CDX-51/51RF

SUPPLEMENT-1

Subject: Mechanism Deck Modification

(ENG-95012)

• New Type Discrimination

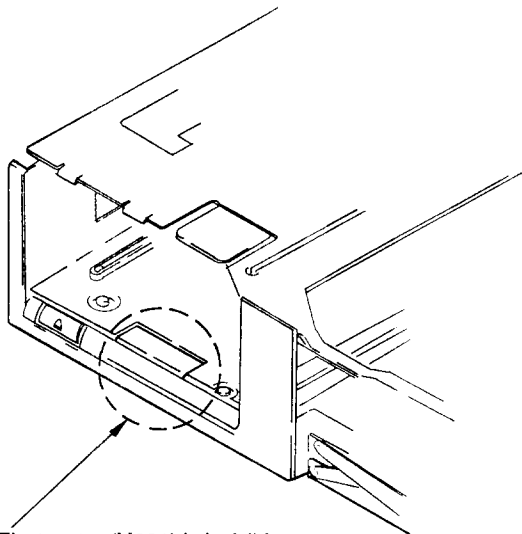
The mechanism deck was changed from MG-108K-132 to MG-108Z-132.
This supplement contains only a new type mechanism deck.
No circuit is changed, and therefore for electrical parts, please refer to the
CDX-51/51RF service manual (9-959-909-11) previously issued.

Former type: Eject motor (M601) is invisible.
New type : Eject motor (M601) is visible.
